UNITED STATES PATENT AND TRADEMARK OFFICE

10/720,752

Office Action Summary

DETAILED ACTION

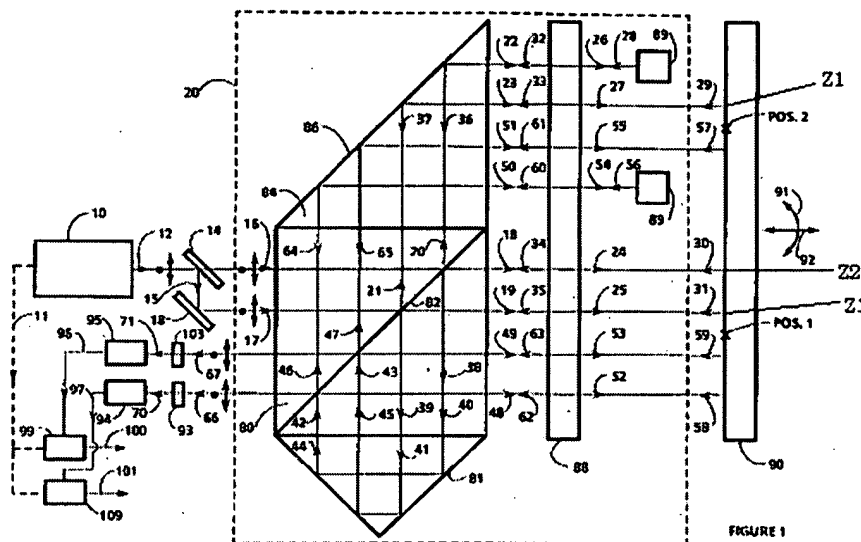
Claims 1-4, and 9 are rejected under 35 U.S.C. § 102(b) as being clearly anticipated by Sommargren(4,859,066).

Note that Z1 and Z2 were added by the Examiner to help explain the measurement mirror areas.

With regard to claim 1, Sommargren teaches an interferometer system for measuring displacement, along at least two directions within a three dimensional system of coordinates, of an object in a plane substantially parallel to a two dimensional plane(Fig. 1), said interferometer system comprising:

a single beam splitter configured to split a radiation beam associated with said plane mirror interferometer system and a radiation beam associated with said differential plane mirror interferometer system into respective measuring beams and respective reference beams(Fig. 1, 80);

at least one measuring mirror fixedly connected to said object and comprising a plurality of measuring mirror areas(Fig. 1, 90); and

at least one reference mirror comprising one or more reference mirror areas that prevent said respective measuring beams and said respective reference beams from passing through said reference mirror(Fig. 1, 89).

a beam generator configured to generate a plurality of radiation beams(Fig. 1; 10,14,18), said beam generator comprising a single beam-splitter block(Fig. 1, 80) having a beam splitting surface(Fig. 1, 82);

wherein said beam splitter block is configured to split at least one first beam of said plurality of radiation beams(Fig. 1, 16) into a first measuring beam(Fig. 1, 18) and a first reference beam(Fig. 1, 20),

said first measuring beam being reflected by a first measuring mirror area of said plurality of measuring mirror areas(Fig. 1; 90,POS.1+Z2), and wherein said beam splitting surface is configured to split at least one second beam of said plurality of radiation beams(Fig. 1, 17) into a second measuring beam(Fig. 1, 19) and a second reference beam(Fig. 1, 21),

said second reference beam being reflected by a first reflector that is fixedly positioned with respect to said beam-splitter block(Fig. 1, 89) and by at least one third mirror area, which is movable with respect to said beam-splitter block(Fig. 1; 90,POS.2+Z1).

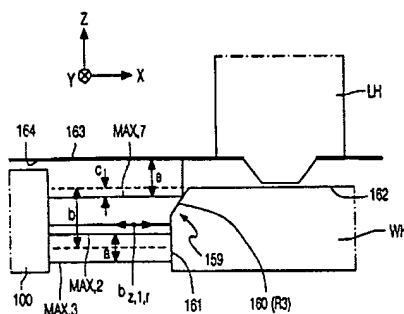
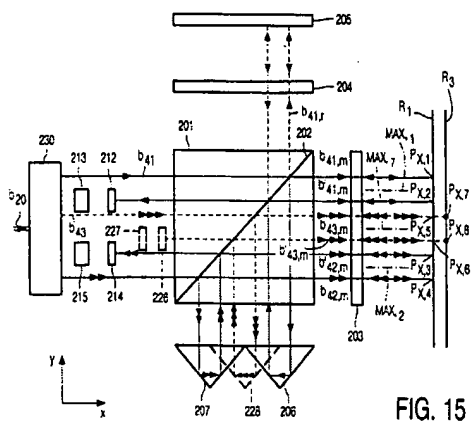
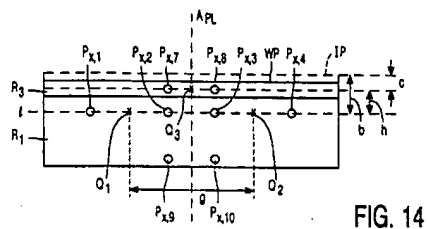
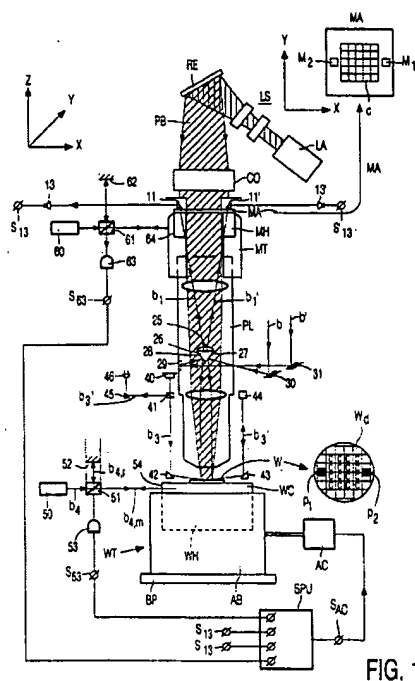
Claims 5-8, and 10-24 are rejected under 35 U.S.C. § 103(a) as being unpatentable over Sommargren(4,859,066) in view of Loopstra et al(6,020,964).

Loopstra et al teach a lithographic apparatus comprising (Fig. 1): an illumination system (column 8, lines 14-17); a support structure for supporting a patterning device (column 8, lines 2-5); a substrate holder for holding a substrate (column 8, lines 5-13); and a projection system (column 8, line 2).

Loopstra et al teach a second reflector fixed to said object(Fig. 5, 160) and a second reference mirror(Fig. 5, 164) area located in a fixed position with respect to said beam-splitter block, wherein said second reflector is arranged to direct said second reference beam towards said second reference mirror area.

Loopstra et al teach a second reflector fixed to said object(Fig. 5, 160) and a fourth mirror area(Fig. 5, 164) which is fixed to a second object, which is movable with respect to the beam-splitter block.

Loopstra et al teach generating a plurality of beams(fig's 10,12; b₂₀) which occupy more than one plane(fig. 14; P_{x,1}-P_{x,10}) and a second radiation beam(fig. 15, b₄₃) in a position between two of said at least three first radiation beams(fig. 14; P_{x,7},P_{x,8}). Thus Loopstra et al can measure displacement along the X and Z axes
